LOST CREEK ISR, LLC

**Re: Response to NRC Request for Additional Information (RAI), Dated November 6, 2008
Technical Report for the Lost Creek Project, Great Basin, Wyoming
Docket No. 40-9068
TAC No. LU0142**

**December 2008 Responses
to the
NRC November 2008 Comments on the
Lost Creek Technical Report**

Pre-2008 Drill Hole Abandonment Status

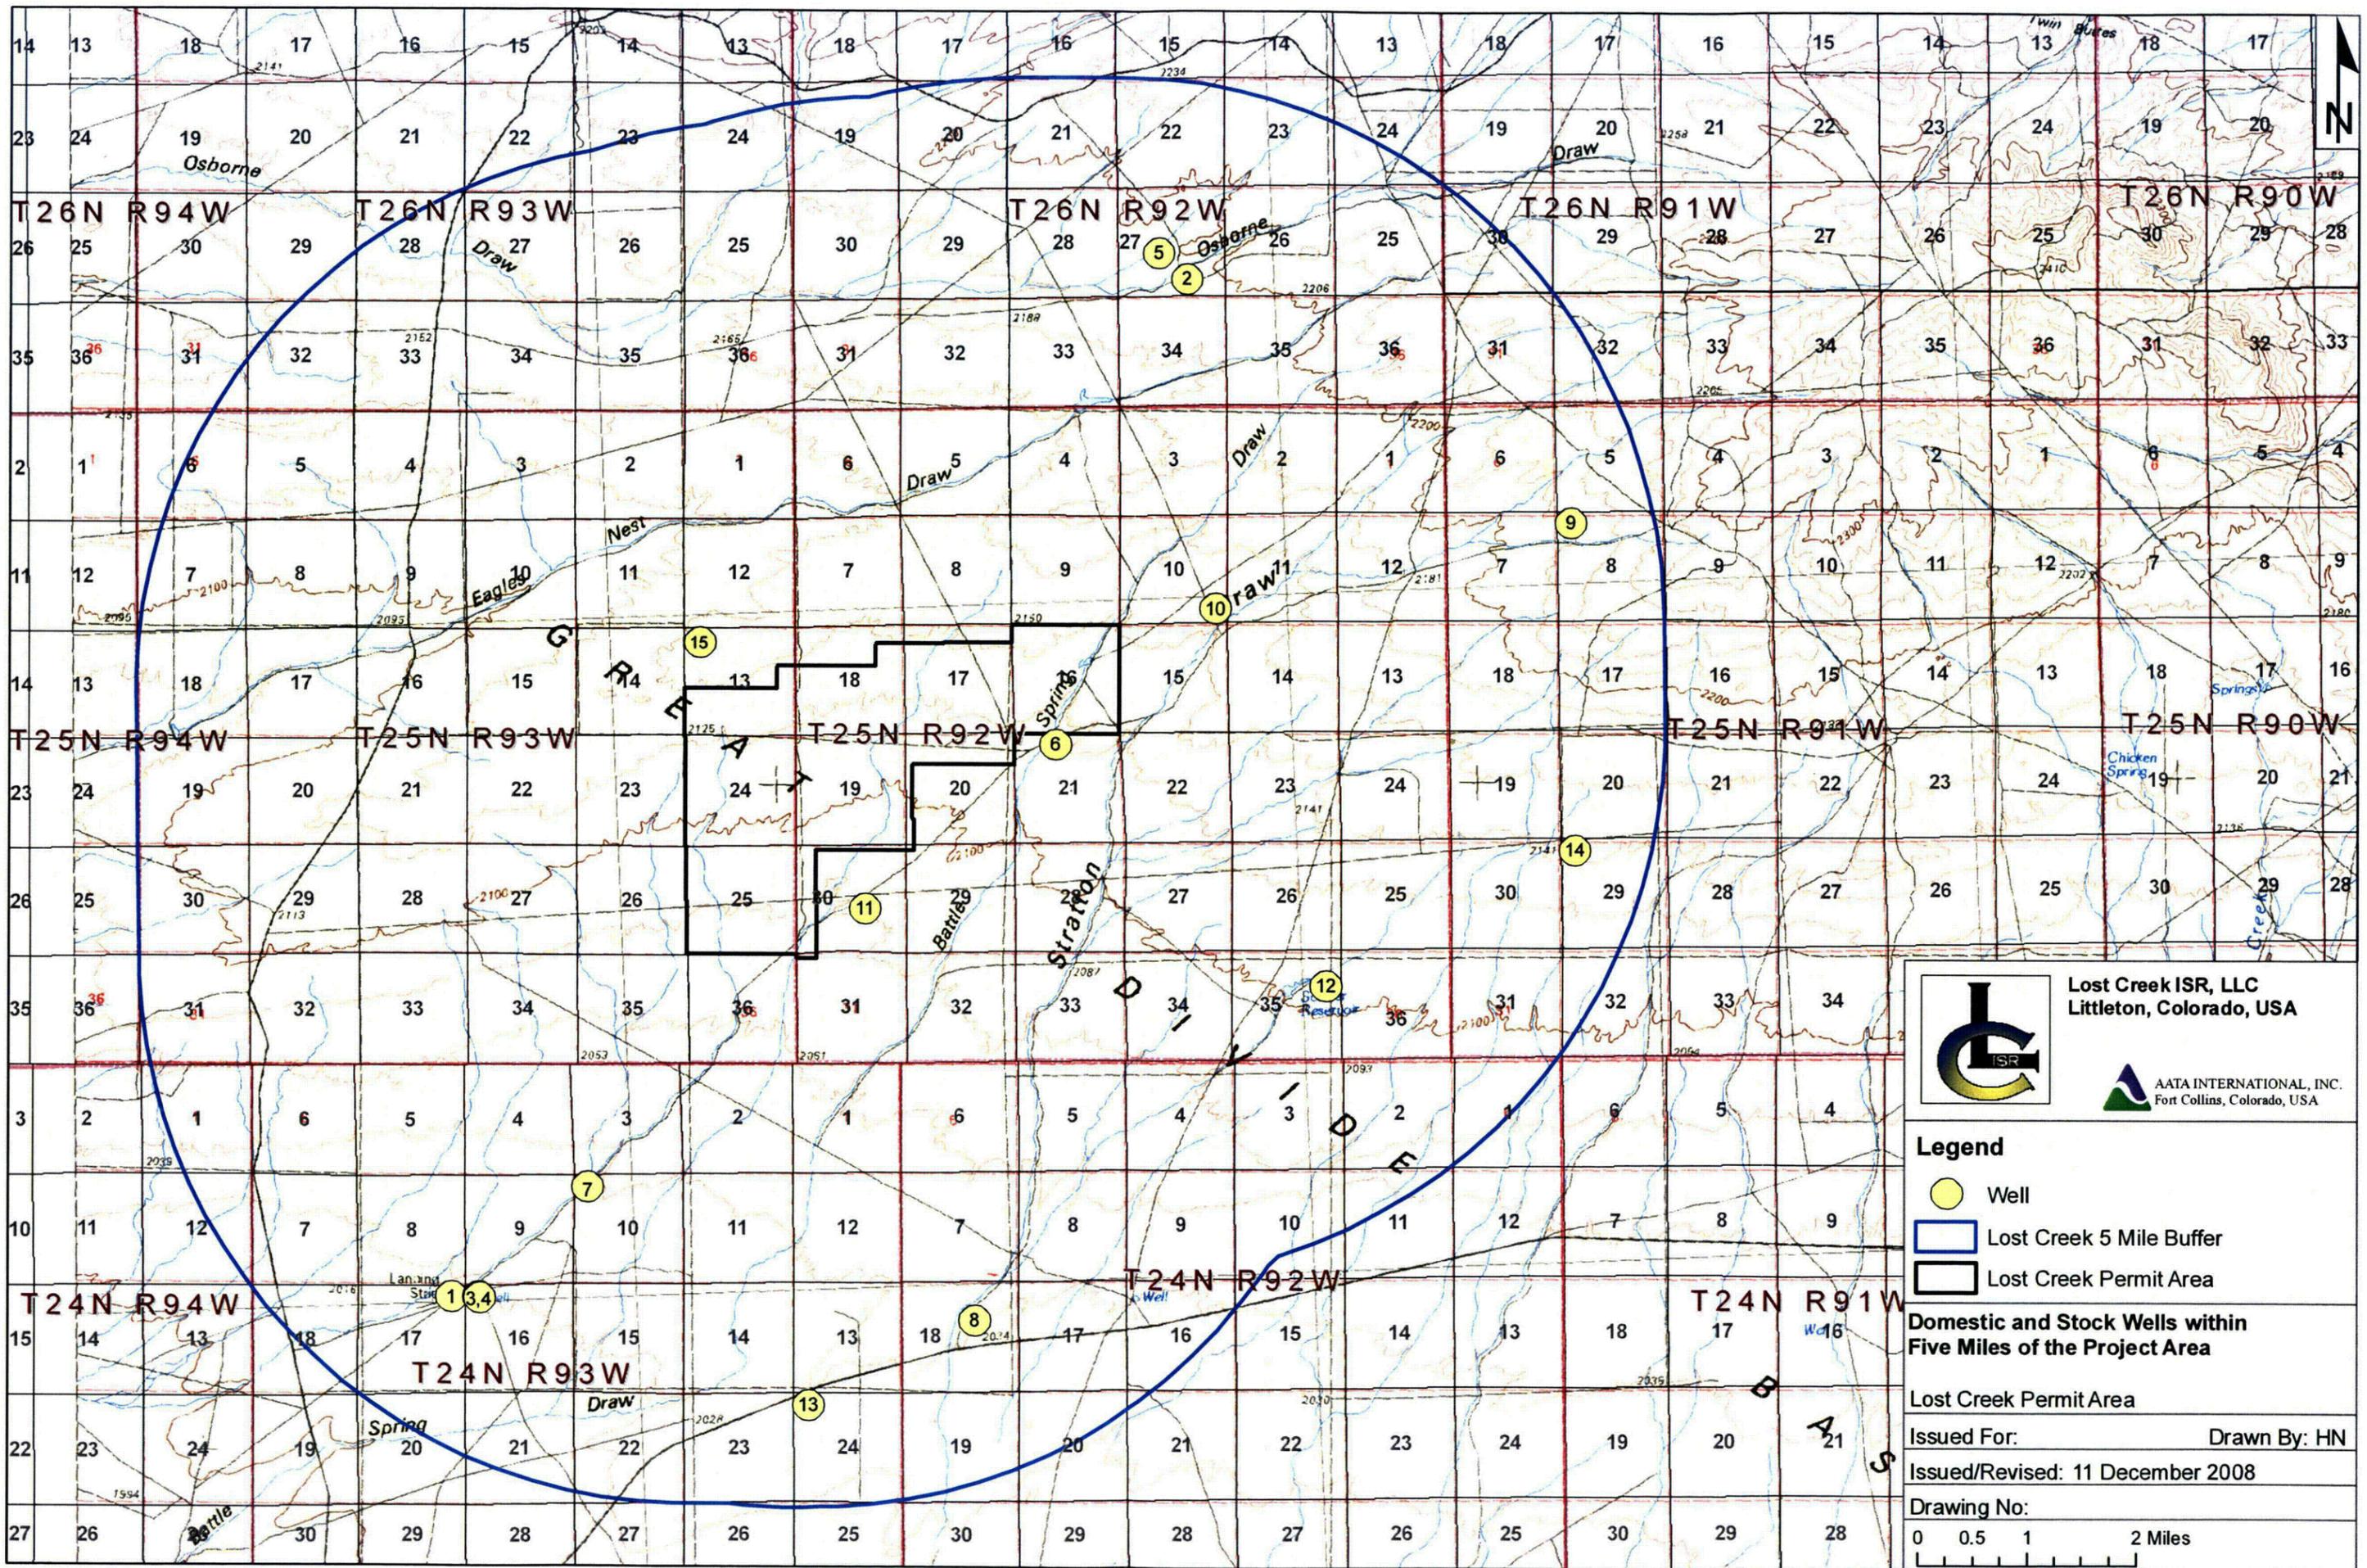
4. Evidence or further explanation of why LCI has confidence that the 560 abandoned exploration holes drilled prior to 2000, shown in Attachment 2.6.2, were sealed and surface plugged in compliance with the State of Wyoming Regulations in effect at the time of drilling.

surface subsidence or near a pump test well was re-entered, when it could be located, and re-plugged. Additionally, in 1983-1984, Texas Gulf completed a program of locating historic drill holes on the property and re-plugging any holes with questionable plugging. The results of the Texas Gulf program are also included in the table. Finally, the results of hydrologic pumping tests will be analyzed to determine the degree of confinement.

FIGURE 2.7-9
Location Map,
Lost Creek Monitor Wells

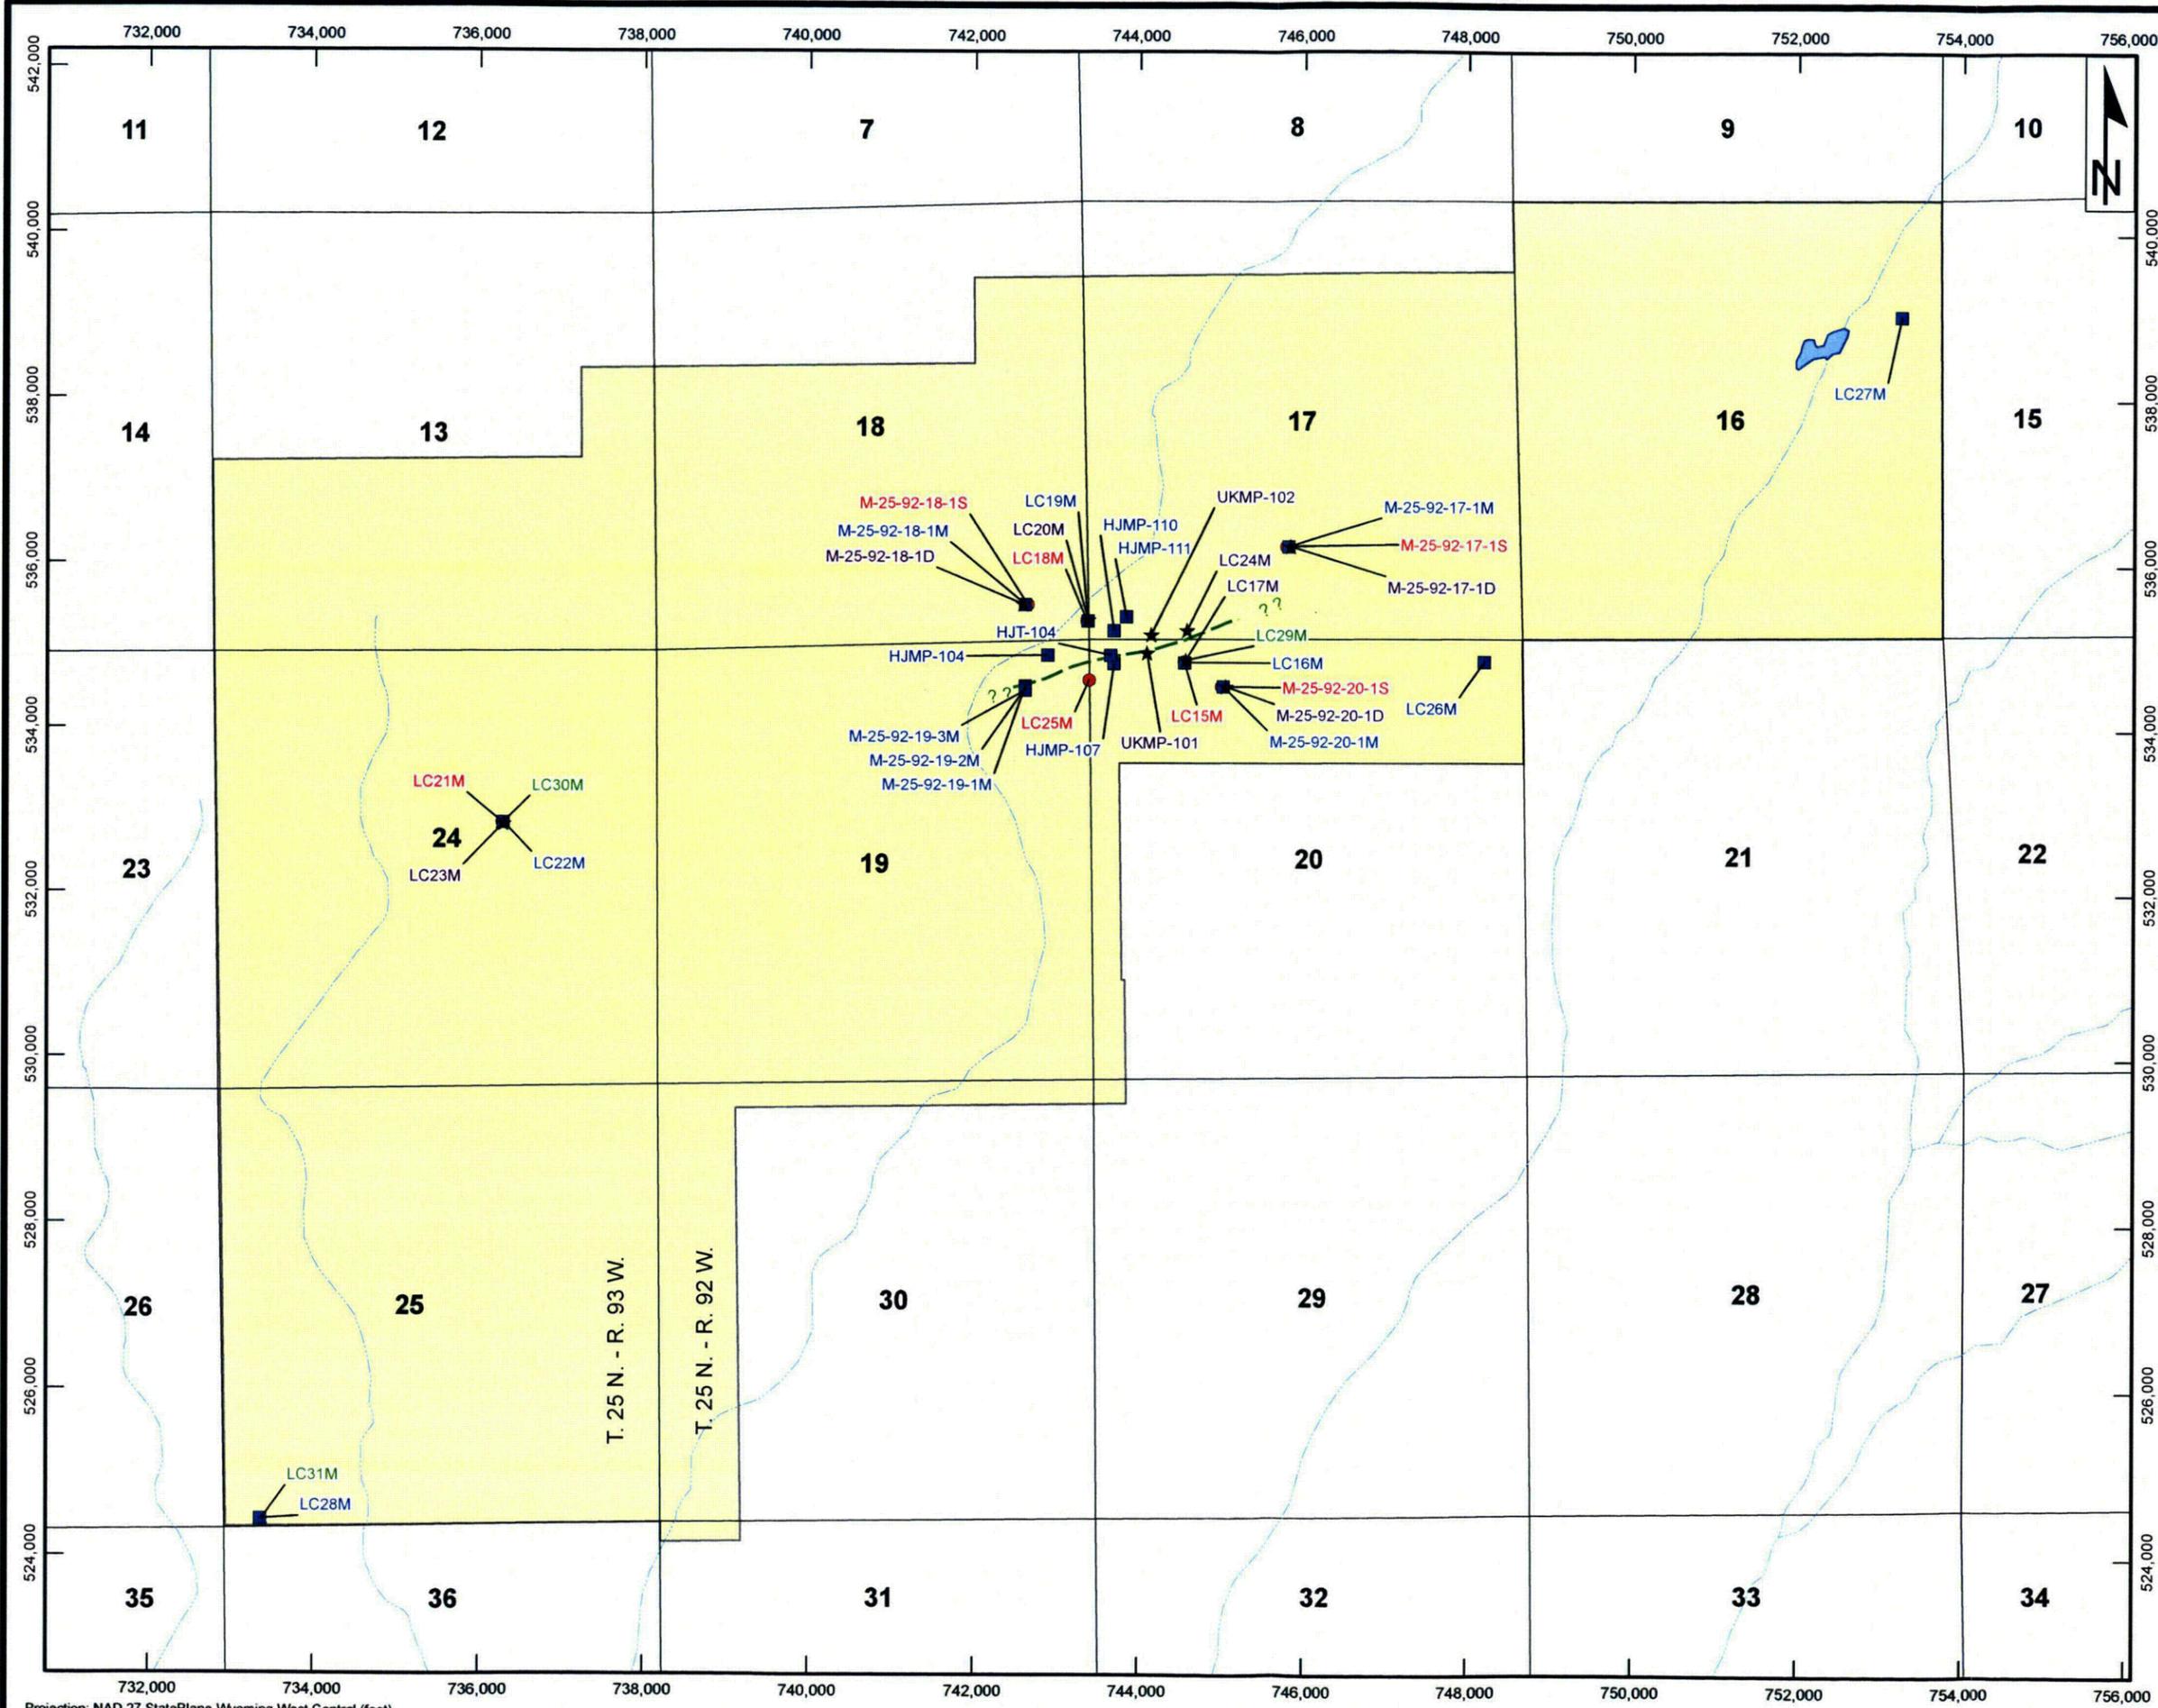
- 5. A correction for the location of monitoring well HJMP 110 on Figure 2.7-9 and clarify other well locations on this map for readability. Also a correction for the township/range numbers on cross section 2.6-1b and c in the small inset maps.***

The location of well HJMP-110 was correct on the figure. However, the labeling may have been confusing. The notations for all the wells on the figure have been made more readable. A revised copy of Figure 2.7-9 is provided at the end of the Responses for TR Section 2.0.

Figure 6-2
Lost Creek Regional Aquifer Test - North Test
 Completed in HJ north of fault

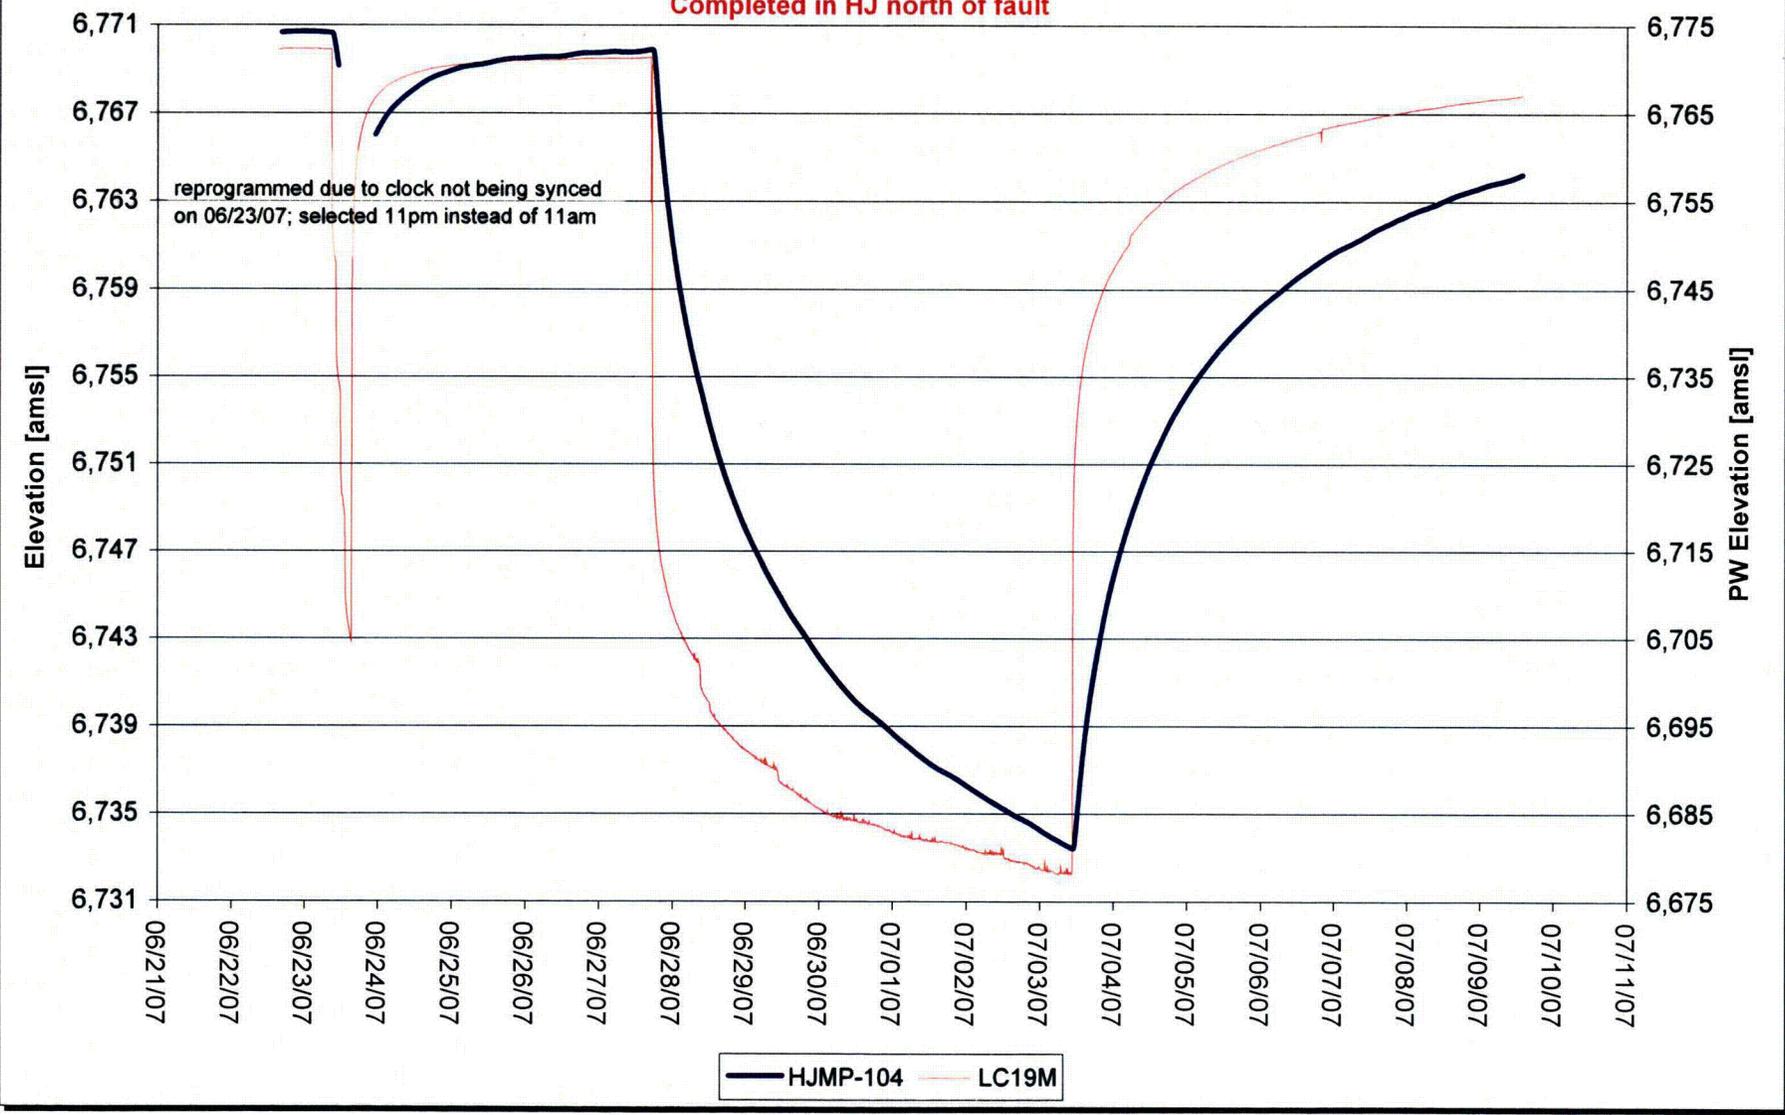
12. ***An assurance that the analysis of the long term pumping test data at LC19M was performed to provide a transmissivity which was not affected by the influence of the fault. This information is important because the drawdown curves provided for the test do not clearly show the time and impact of intercepting a sealing fault. The sealing nature of the fault is evident on the recovery plots.***

From TR Attachment 2.7-1 (Lost Creek Regional Hydrologic Testing Report #1):
Revised Figure 6-2 - Water Level Elevations - Wells HJMP-104 and LC19M;
6-6 - Water Level Elevations - Wells UKMO-102 & LC19M;
6-8 - Water Level Elevations - Wells HJT-105 and LC19M; and
6-10 - Water Level Elevations - Wells UKMO-101 and LC19M.
